Sub: Permission for downloading trial software for M/s. Siemens make Three phase drive propulsion.

Joint Note

Sub: Demonstration of 2.09 software trial

TM-4 and Rectifier 1 of TC-2 pictogram

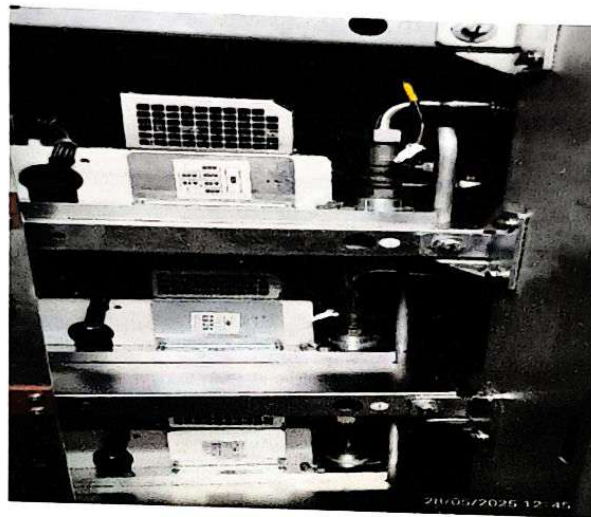
- 3) 1/4th redundancy was working normal with crew messages for driver and diagnostic event. The fault message code for the rectifier module 2 in TCC1 was 0333 and rectifier module 1 in TCC-2 was 0334 and after isolation, nodes were reaching 596 with TE of 5-20 KN in standstill conditions. The same is depicted below in the snapshot for rectifiers of both TCC.

TCC2 Rectifier-1 & TM4 cutout by removing X1 connector.

4QC Pulsing will Start in 590 Node

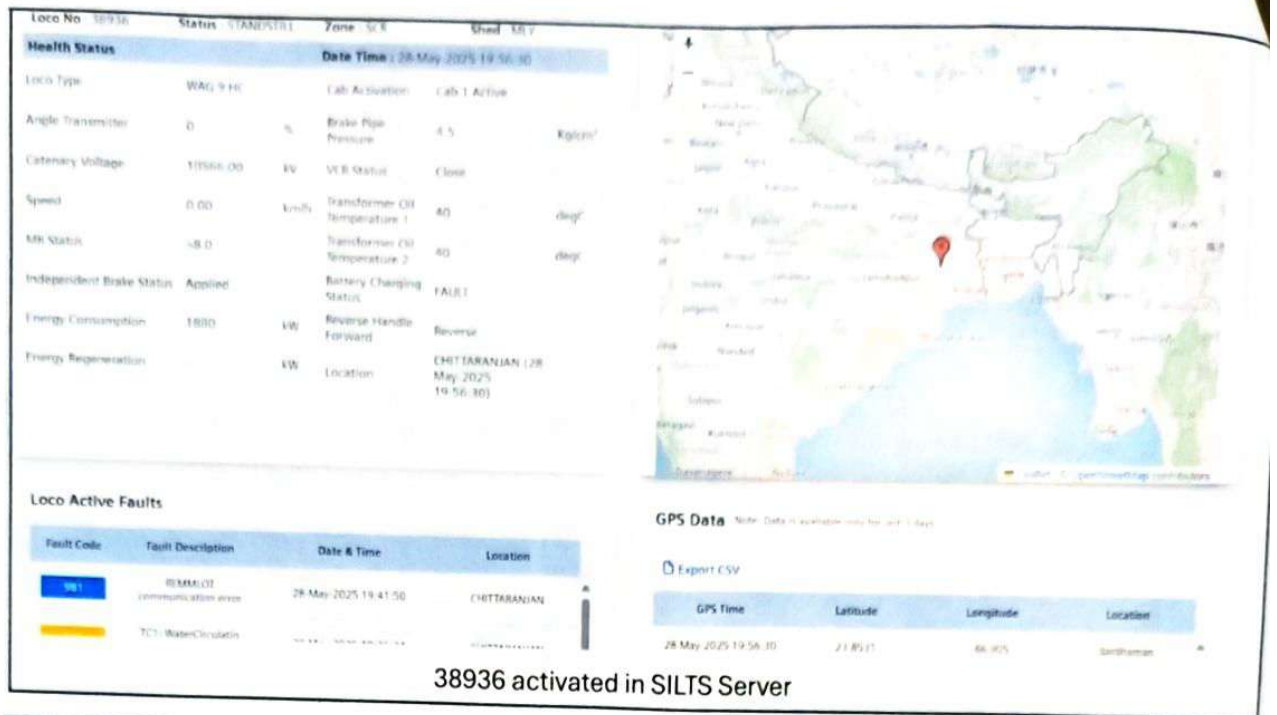
- 12) M/s SIEMENS intimated that pulsing sequence of BUR has been modified to address the issue being faced in ZRs. During testing at CLW no abnormal tripping of BUR is reported due to the pulsing sequence. However it was observed that DC link Voltage was building only after throwing throttle which is above 590 Node so the issue of DC link voltage charging at 570 Node has been rectified. Thus, the efficacy of the same needs to be verified at ZRs
